Report of the Committee of Experts on the Transport of Dangerous Goods and on the Globally Harmonized System of Classification and Labelling of Chemicals on its tenth session

Addendum

**Amendments to the eighth revised edition of the Globally Harmonized
System of Classification and Labelling of Chemicals (GHS)
(ST/SG/AC.10/30/Rev.8)**

“Decision logic 2.2

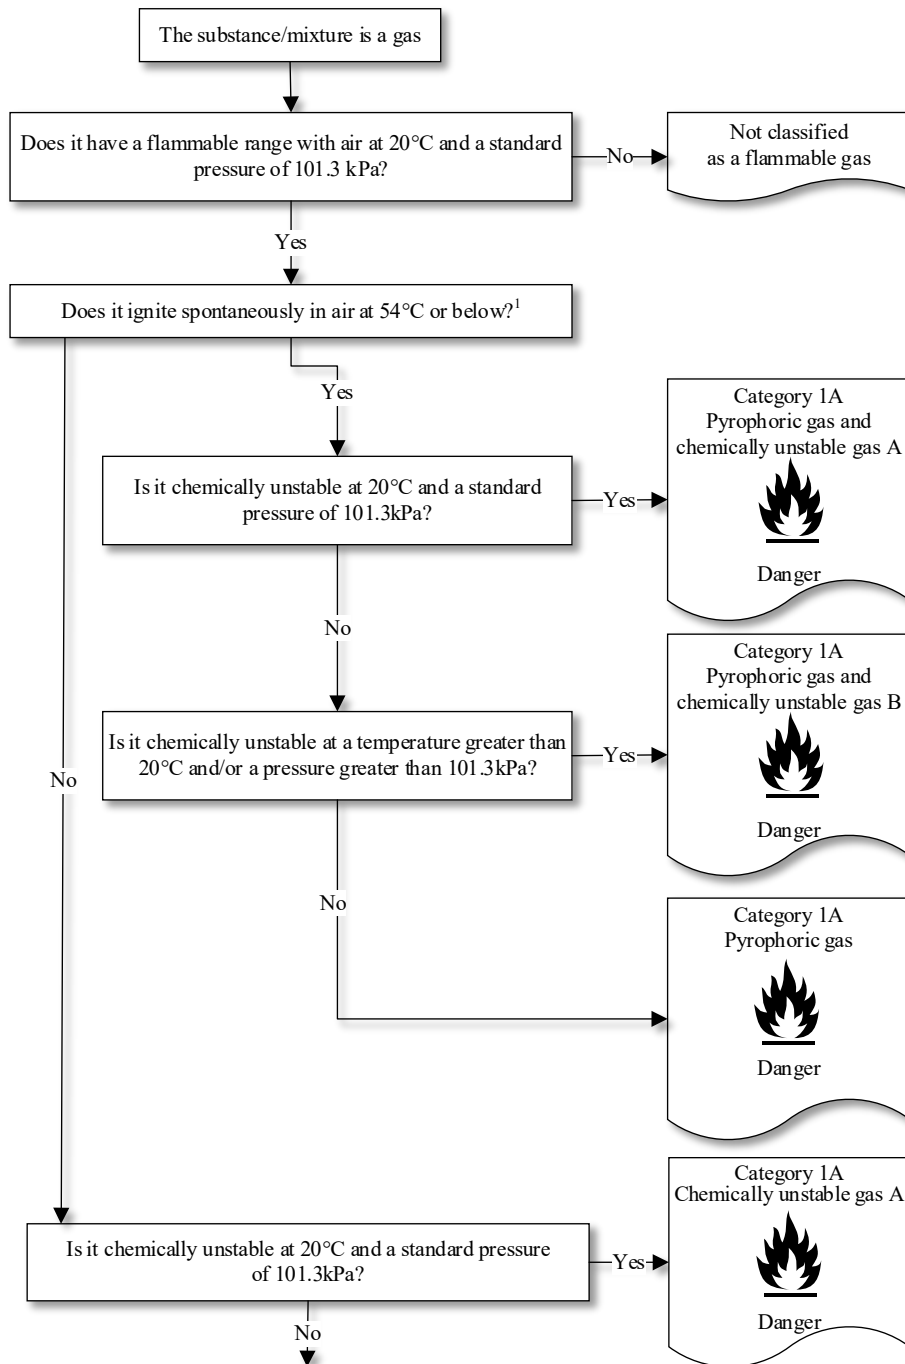
2.2.4.1 Replace decision logic 2.2 with the following (*the text of the footnote remains unchanged*):

“Decision logic 2.4 for oxidizing gases

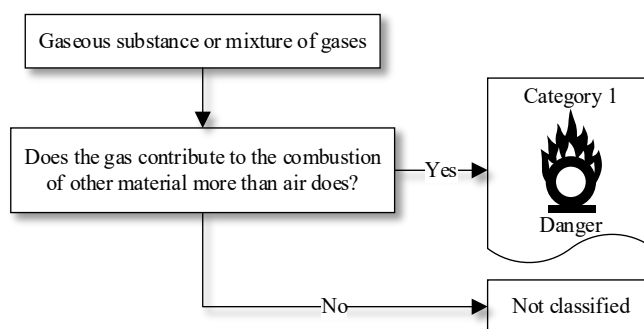
2.4.4.1 Replace decision logic 2.4 with the following:

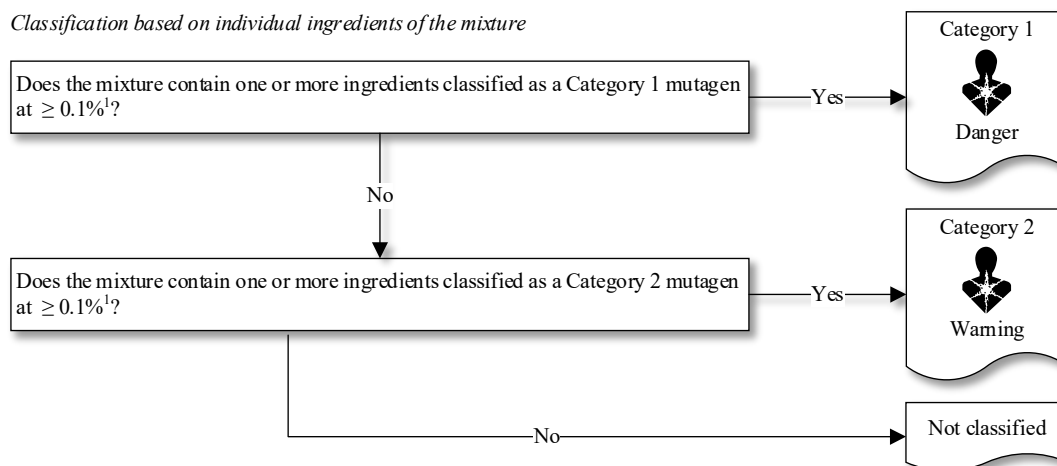
3.5.5.1.2 Replace decision logic 3.5.2 with the following (*the text of the footnotes remains unchanged*):

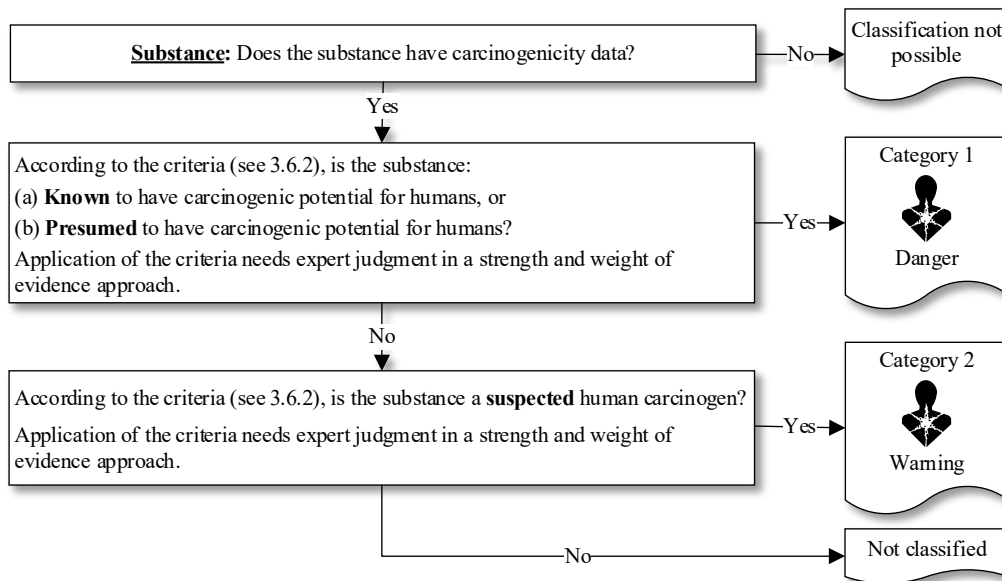
3.6.5.1 Replace decision logic 3.6.1 with the following:

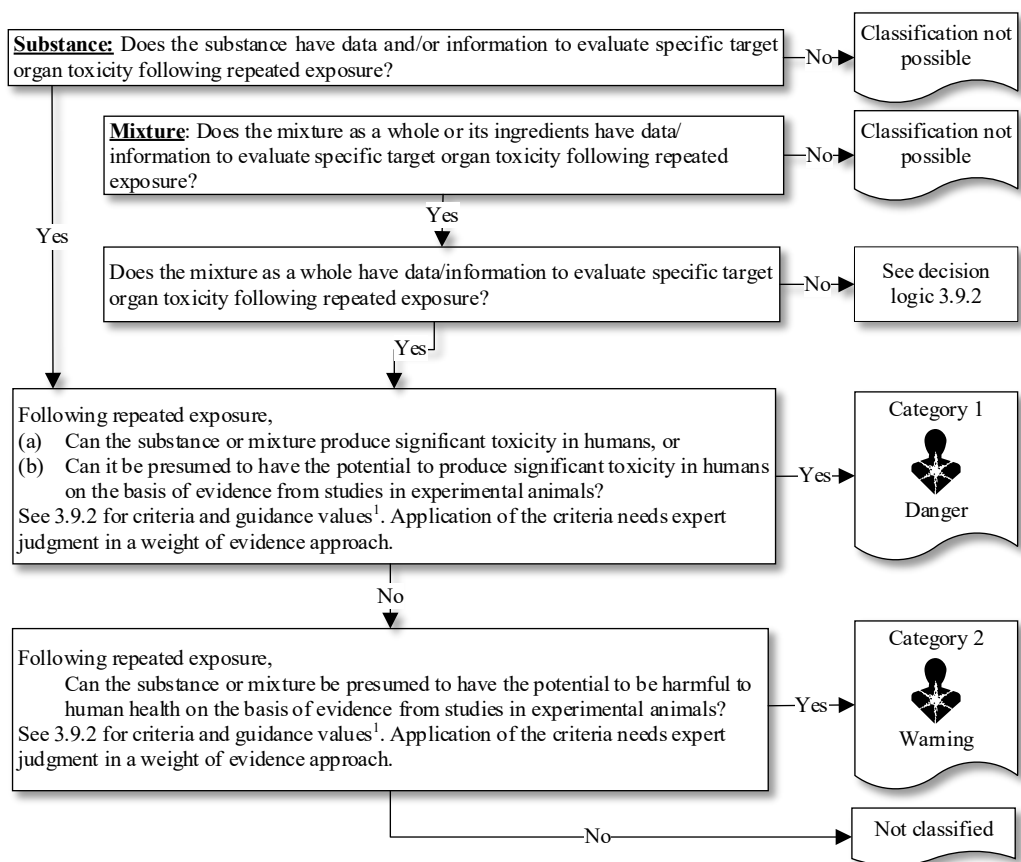
3.9.5.1 Replace decision logic 3.9.1 with the following (*the text of the footnote remains unchanged*):

“*Decision logic 4.2.1*”

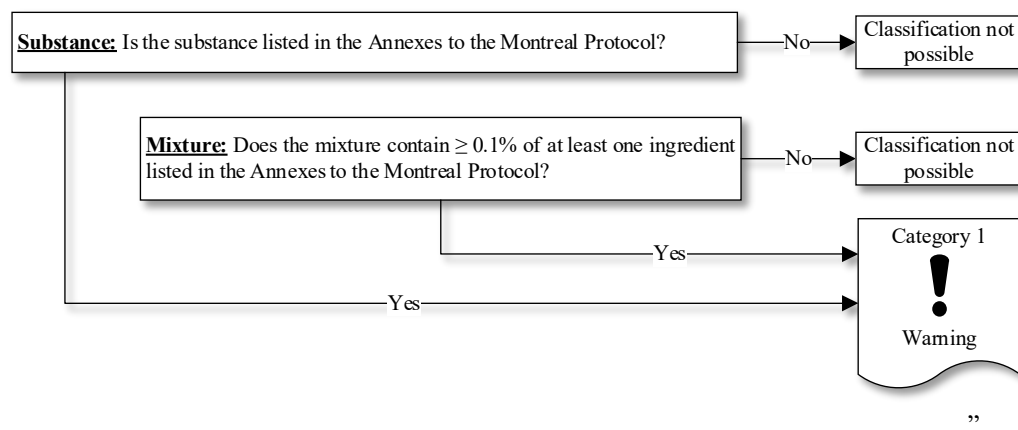
4.2.4 Replace decision logic 4.2.1 with the following:
